Transcontinental Gas Pipe Line Company, LLC

Response to Technical Deficiency Pennsylvania Department of Environmental Protection

Atlantic Sunrise Project

Table 1
Transco's Responses to DEP July 29, 2016 Technical Deficiencies Letter

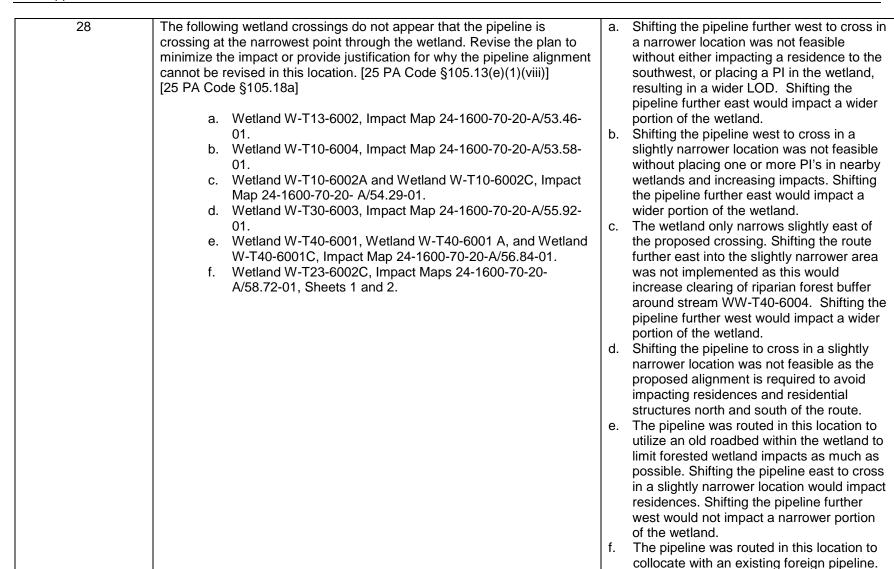
kkkk. Shifting the pipeline northwest to avoid this wetland was not implemented as this would require construction on steep side slopes.
